RECEIPT DATE: 7/10/18 **ONSITE SEWAGE DISPOSAL SYSTEM** P 563953  
 APPROVAL DATE: 7/11/18 **PERMIT: CONSTRUCTION** A \_\_\_\_\_  
 PROPERTY ADDRESS: 12218 Pleasant Springs Court  
 SUBDIVISION: Regan Property LOT: 16 TAX ID: \_\_\_\_\_  
 CONTRACTOR: Fogle's Septic Clean Inc. EMAIL: kim@foglesinc.com  
 CONTRACTOR ADDRESS: 580 Obrecht Road, Sykesville, MD 21784 PHONE: 410-795-5670  
 PROPERTY OWNER: MB Highland Reserve EMAIL: \_\_\_\_\_  
 OWNER ADDRESS: 1686 E. Gude Drive, Rockville, MD 20850 PHONE: 410-301-762-9511

DATE	9/6/18	PROJECT No.	2171
ATTENTION	Kevin Wolf		
RE:	Regan Property Lot 16		
	12218 Pleasant Springs Ct

PROJECT: **REGAN PROPERTY LOT 16**

TITLE: **ONSITE SEWAGE DISPOSAL SYSTEM DESIGN PLAN**

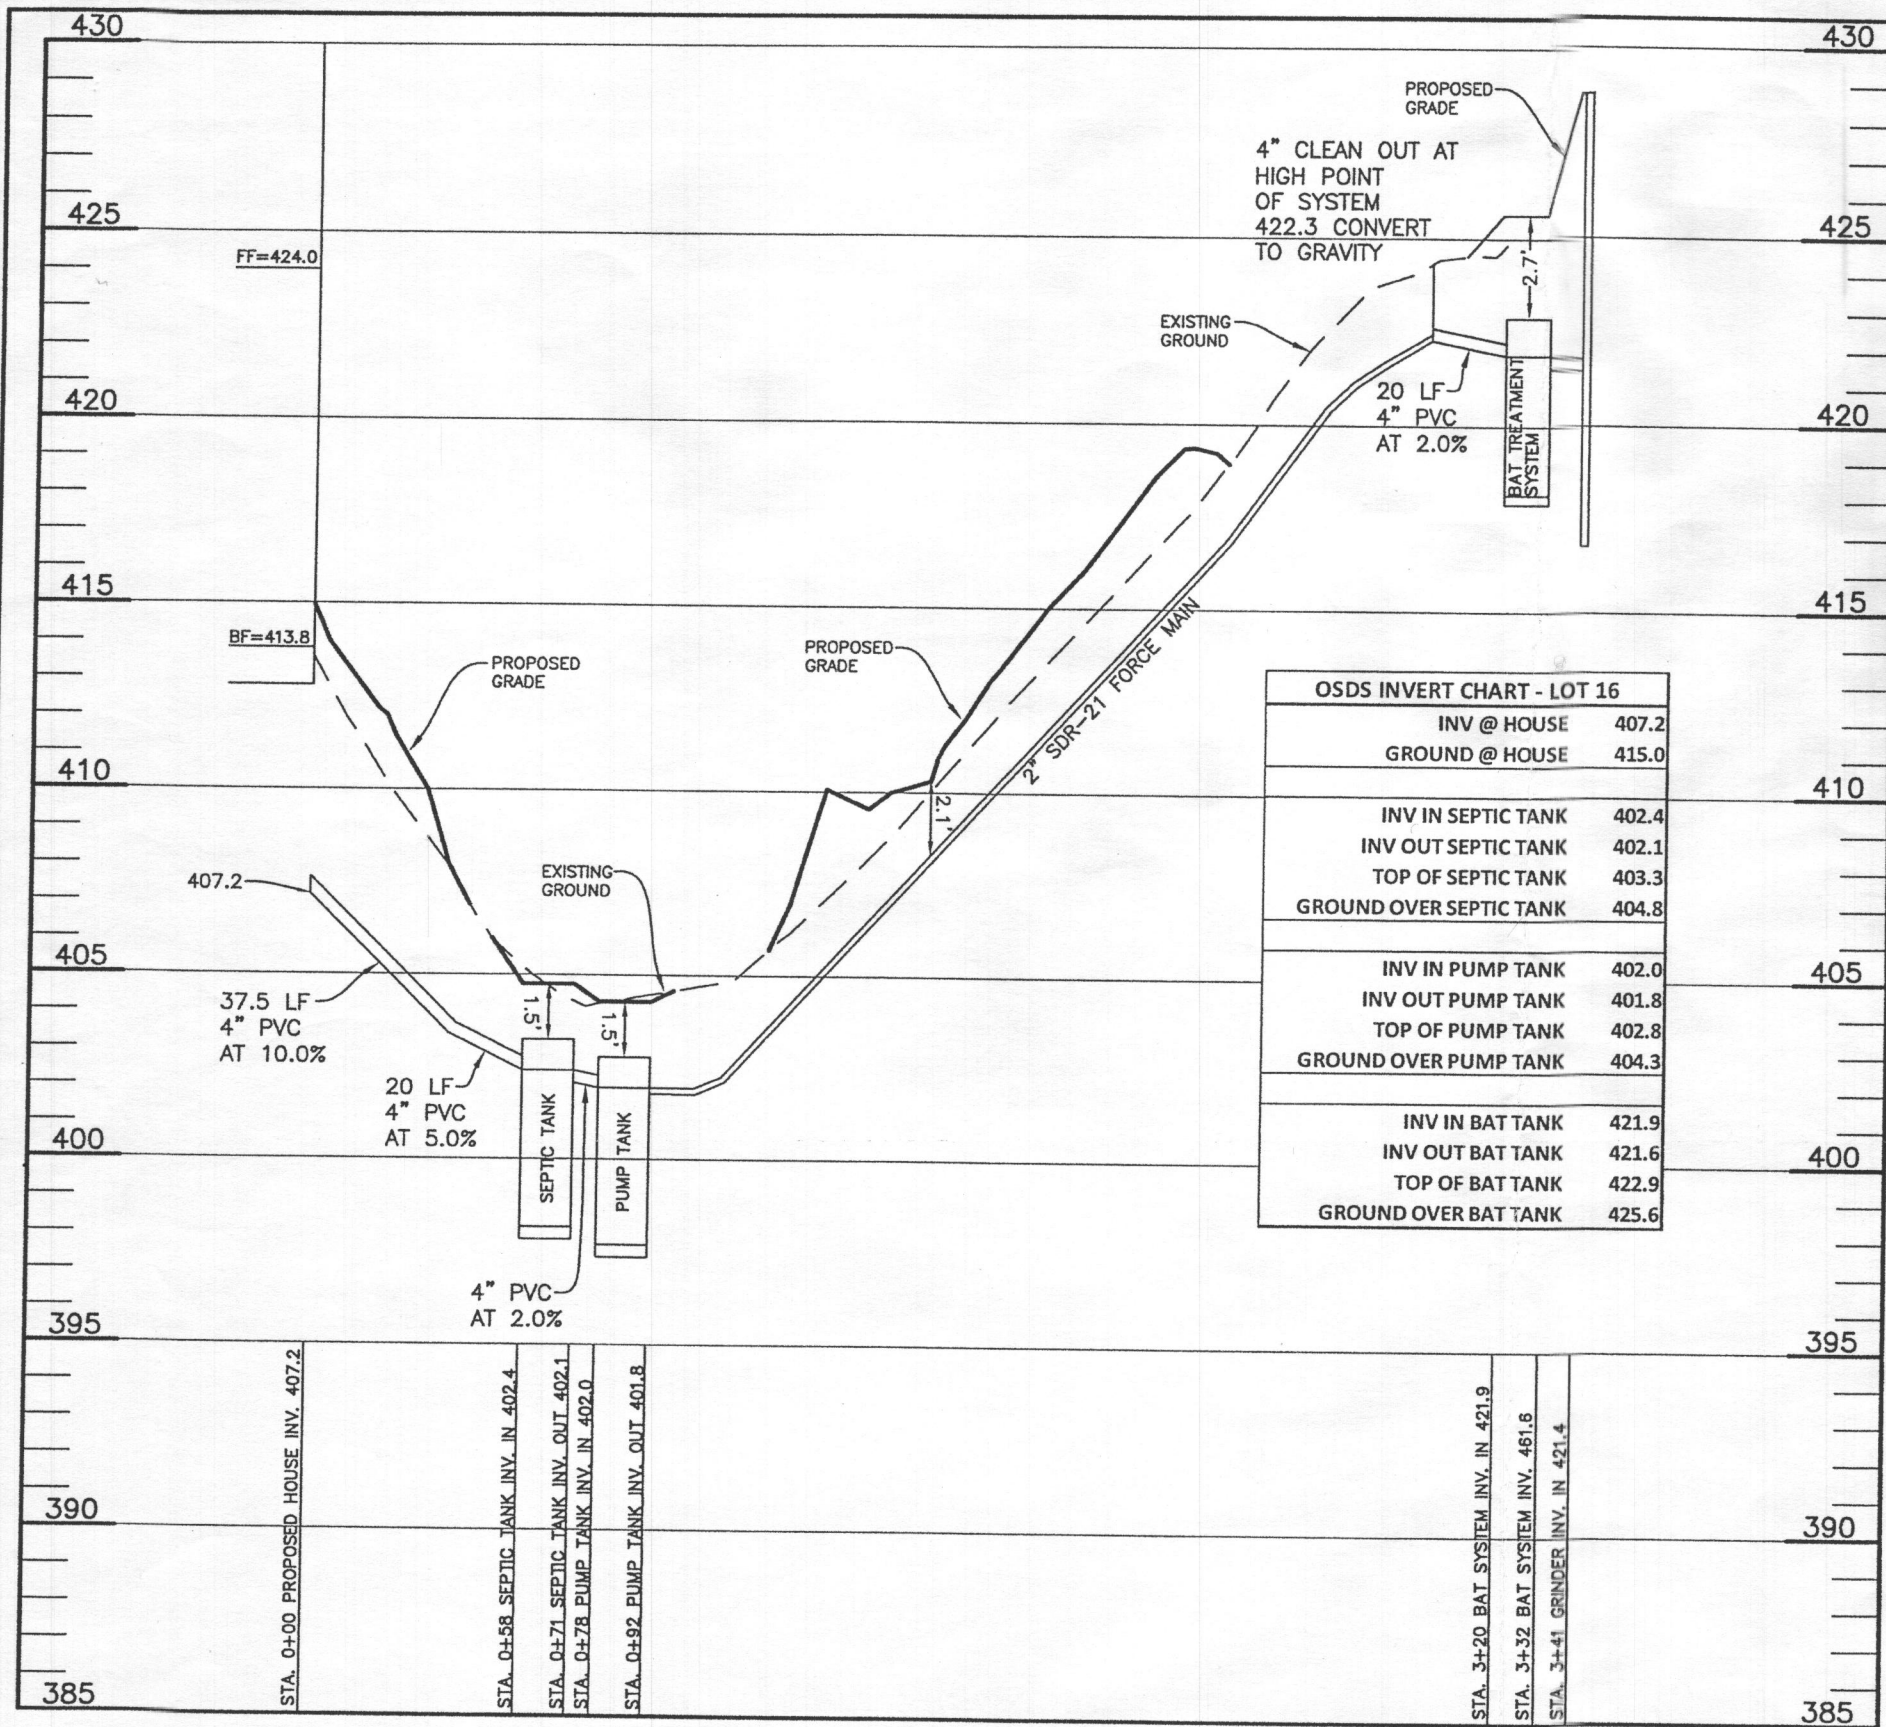
This lot was brought to my attention when the septic contractor came in to get this permit. The issue here is how the design is set up. You show the sewage line leaving the house going to a single compartment pump tank, and pumping up from there to the BAT unit. This is not how normal septage treatment is performed. We would want the sewage leaving the house going to a septic tank or BAT unit then to a pump

tank moving the sewage to its destination. In this case, we have a grinder pump pumping the waste water to the shared septic fields.

I have confirmed with the BAT rep (Matt Geckle) that we cannot pump up to the BAT. In lieu of this, he recommended adding a 1000g single compartment septic tank in front of the BAT unit (but outside the utility easement) to accept the effluent from the pump tank. This tank will help settle out the solids prior to going in the BAT via gravity. Now the pump tank near the house should utilize a pump capable of handling all domestic waste from the house. You proposed a zoeller effluent pump which can only handle ½" solids which has been shown to "choke up" with solids greater than ½".

Please revise the current OSDS plan to reflect these changes. The septic permit is on hold until we receive the proposed changes. If you have questions or comments, please contact me. I have also cc'd Matt Geckle if you need to reach out as well.

REMARKS: We added a second tank for the septic outfall. The price of this option was acceptable to M&B. Did not reach out to Norweco or Zoeller.

**TITLE:** ONSITE SEWAGE DISPOSAL SYSTEM DESIGN PLAN

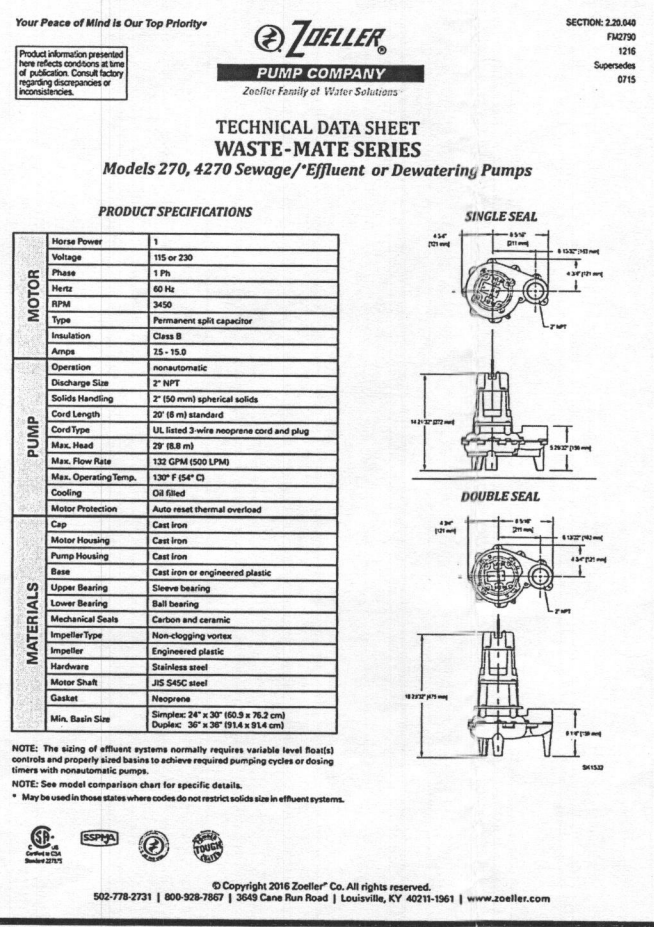
John,  
We have done this before but in slightly different circumstances. For instance, in this case if we use a 2000g 2-compartment tank, the septic tank (or first compartment) would be the 1500g and the second compartment would only be 500g. This is does not provide adequate storage of 24hrs (750g 5 bedroom design) above the high water alarm. I am not sure this is something we want to approve for this situation for the homeowner. I can dicuss this further with Jeff and get back to you.

After an extensive review on this, I think it would be best if we revise the plans to reflect a 1500 gallon 2 compartment septic tank into a single compartment 1500gallon pump tank with a standard effluent pump. There will be some nitrogen reduction prior to it pumping up to the BAT but this is ultimately the best sequence to this type of design. As well as meeting regulations.

**TITLE:** ONSITE SEWAGE DISPOSAL SYSTEM DESIGN PLAN

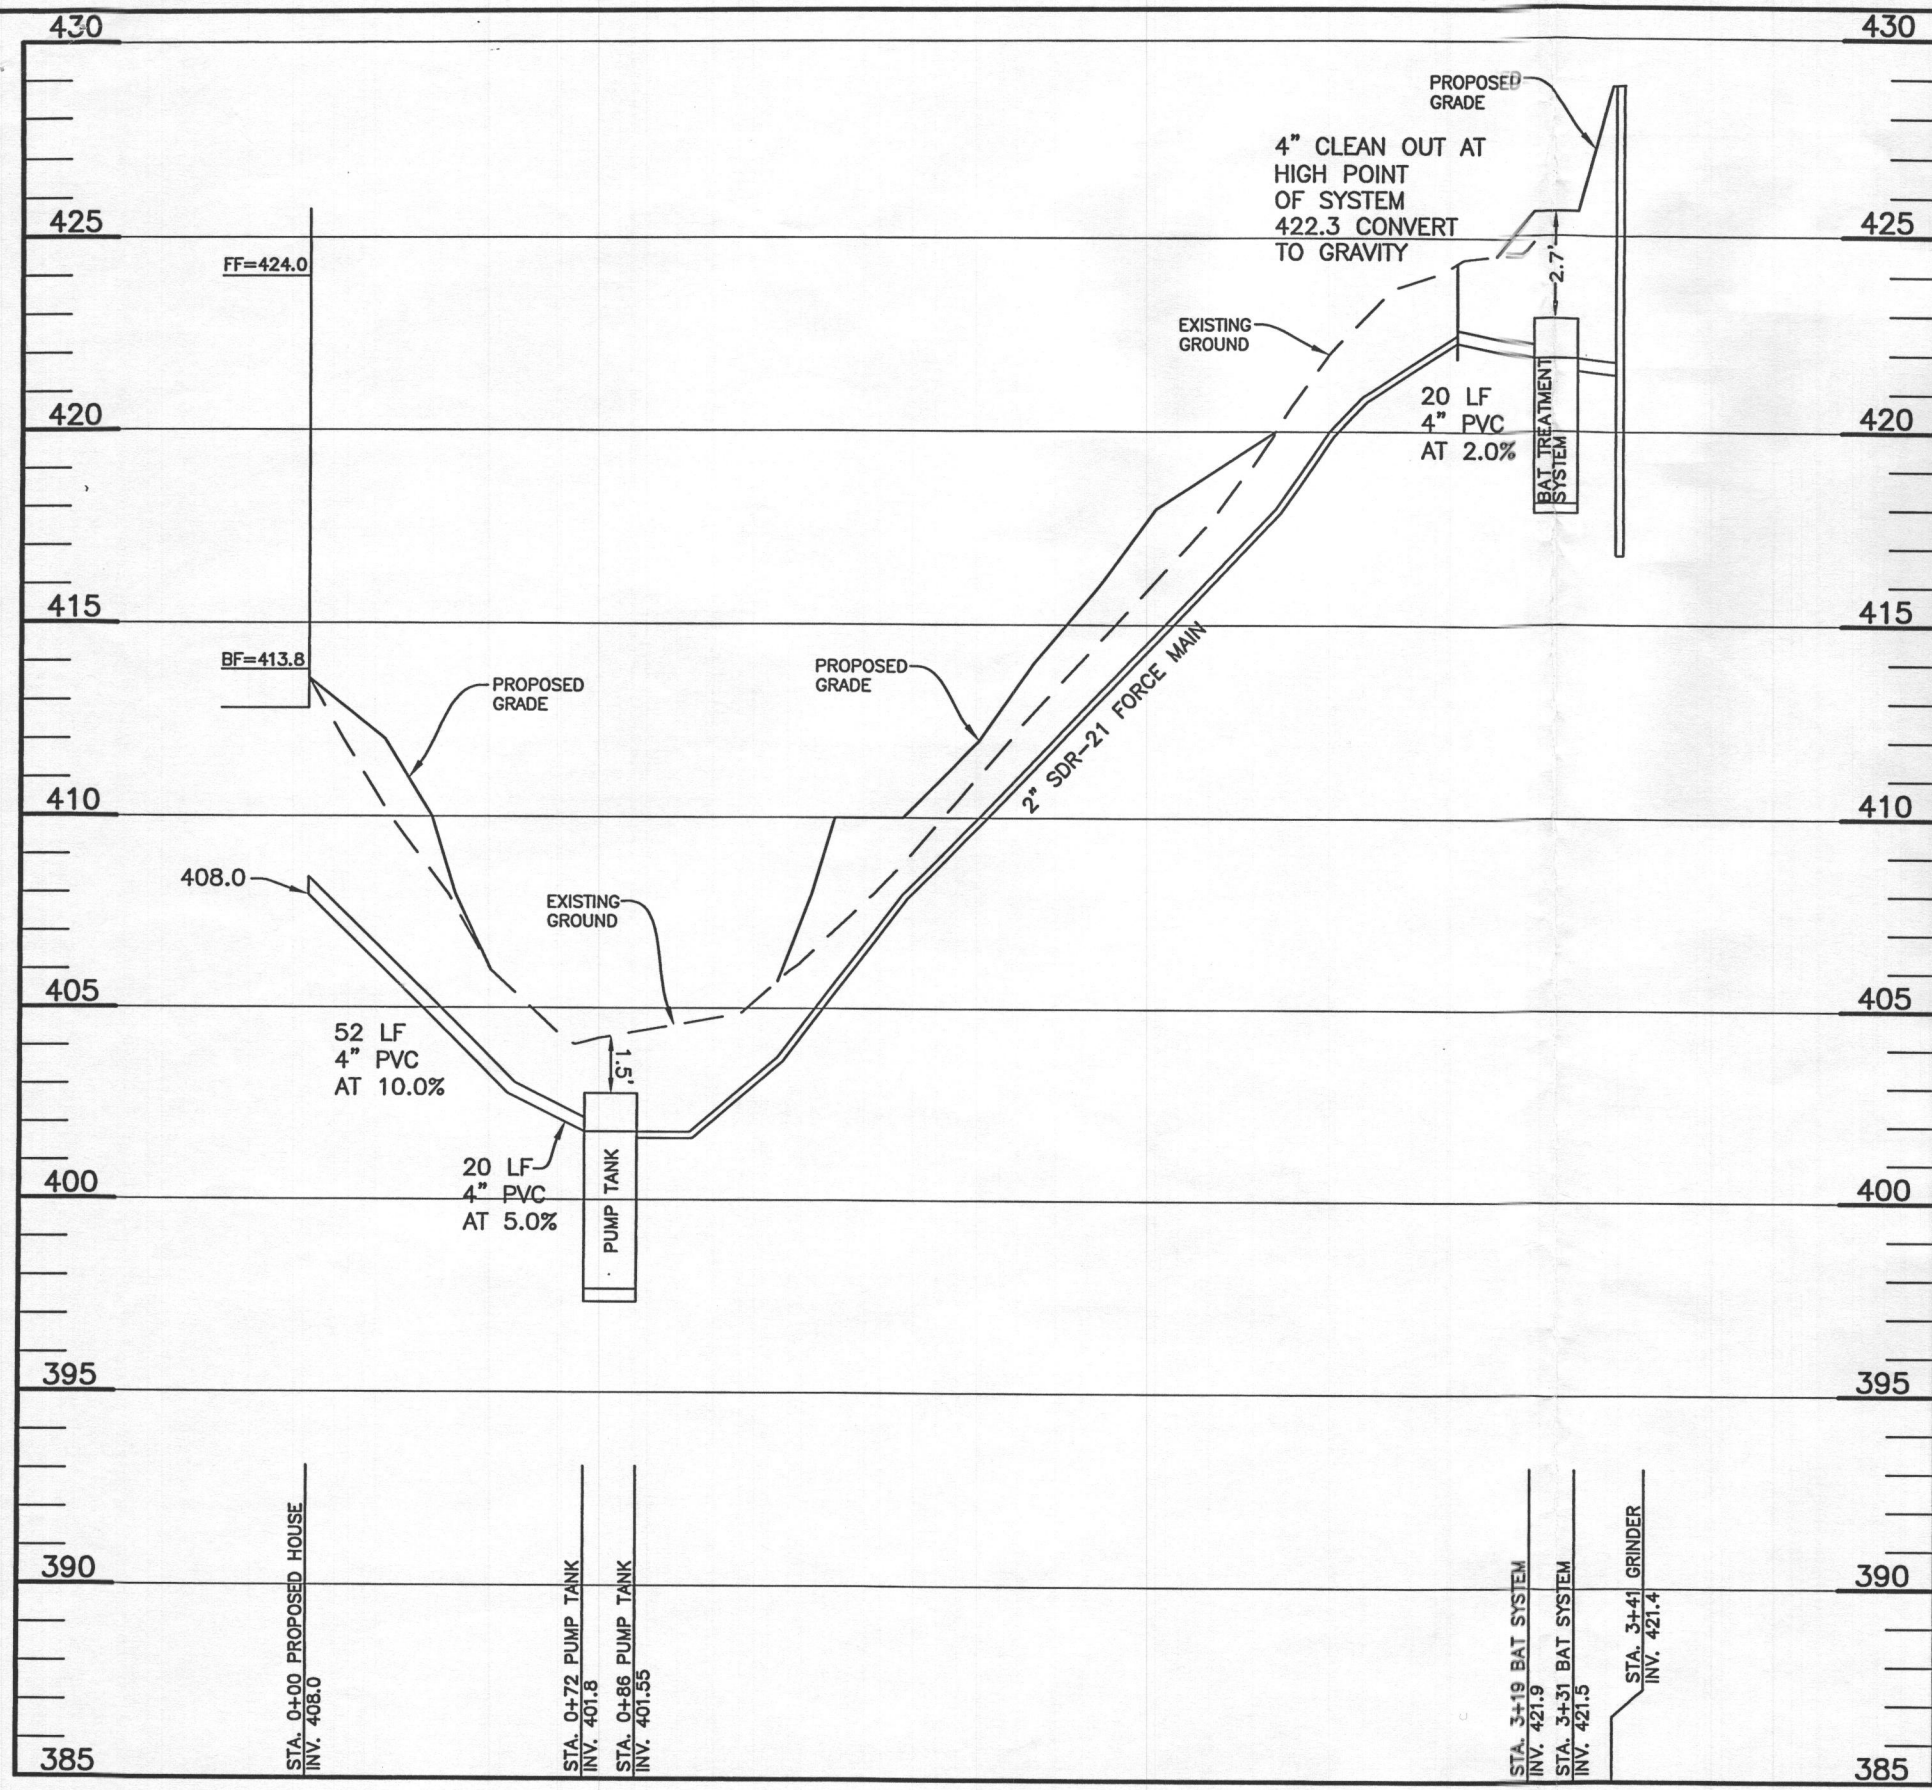
This would be fine but we would need to review the spec's for the pump you select that would handle the solids. The current design you show just the single compartment pump tank. You would either need to show a conventional 2 compartment septic tank followed by a single compartment pump tank w/ standard effluent pump or a single compartment pump tank with an acceptable pump capable of handling 2" solids.

REMARKS: Matt Geckle thought the plan  
looked good. Pump passes 2.0" solids.
